Errata to IEEE Standard Test Specification for Thyristor Diode Surge Protective Devices

Correction Sheet

Issued 23 October 2009

Correction Sheet to IEEE Std C62.37-1996

Figure 17—Switching and on-state waveforms for a positive breakdown slope thyristor SPD

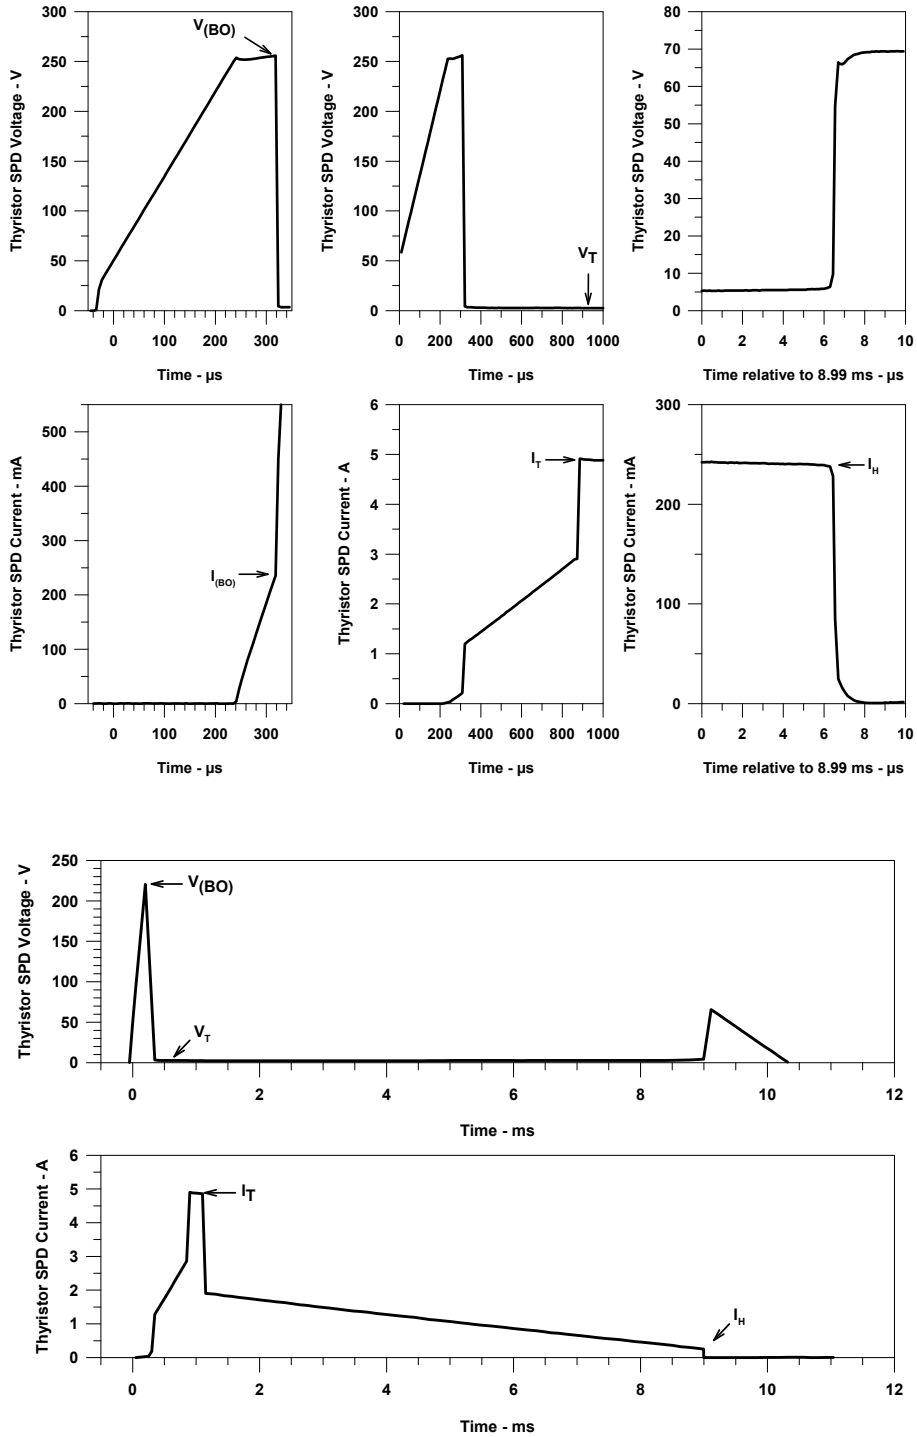
Page 23, Subclause 4.5.3, Figures 17, 18 and 19 should be as follows:

Figure 29—Thermal impedance ($Z_{\theta JA}$) vs. time

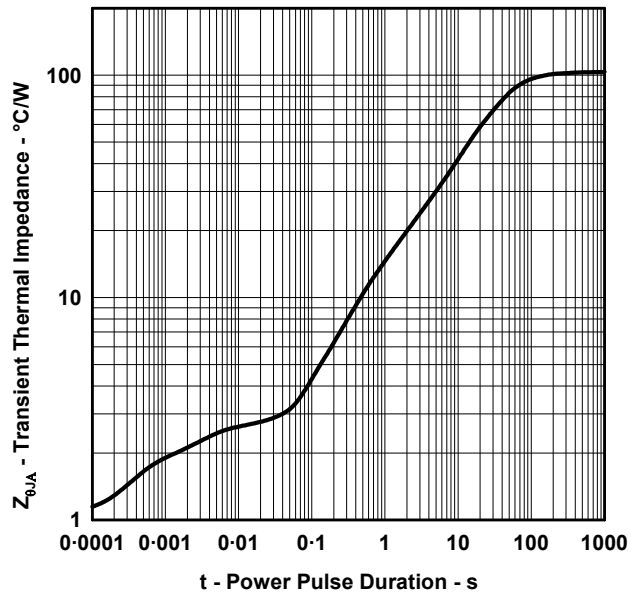
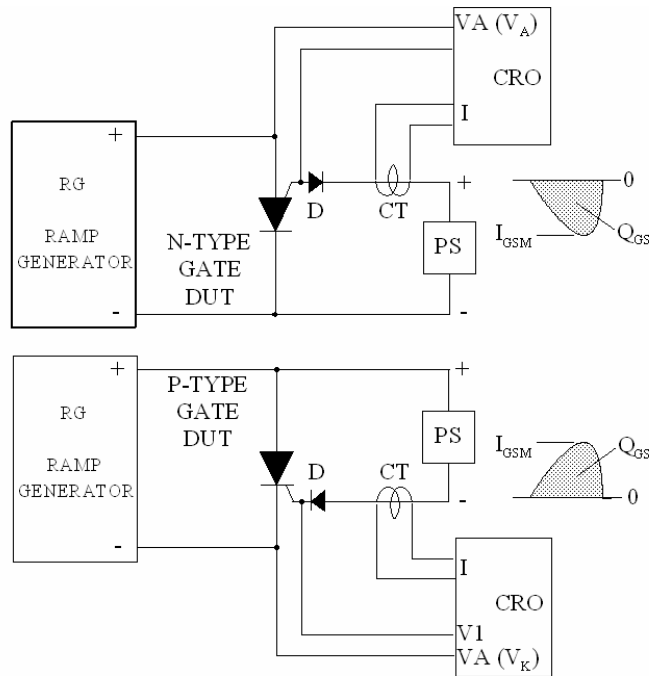
Page 35, Subclause 4.5.18, Transient thermal impedance— $Z_{\theta(t)}$, Figure 29 should be as follows:

Figure 37—Overall and expanded clamping waveforms for a p-type gate DUT to illustrate $V_{GK(BO)}$ and Q_{GS} measurement ($di_K/dt=10 \text{ A}/\mu\text{s}$)

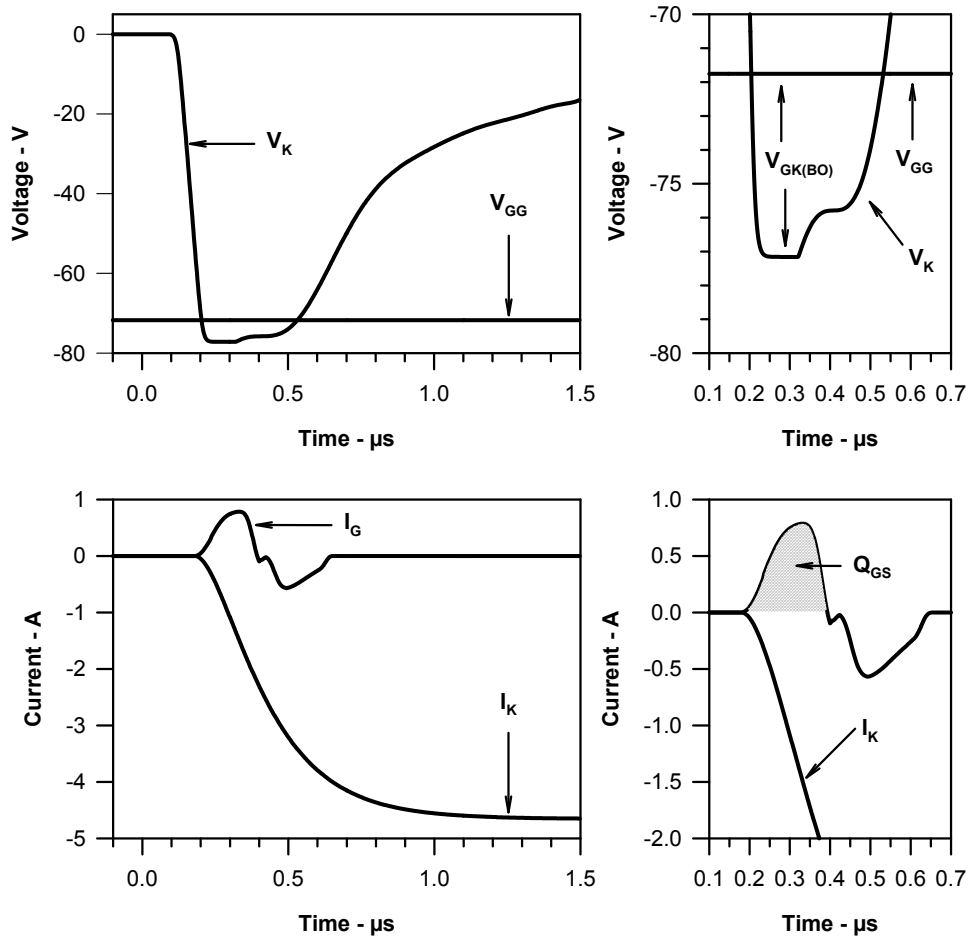
Page 42, Subclause 4.5.24, Gate switching charge— Q_{GS} , Figure 37 should be as follows:
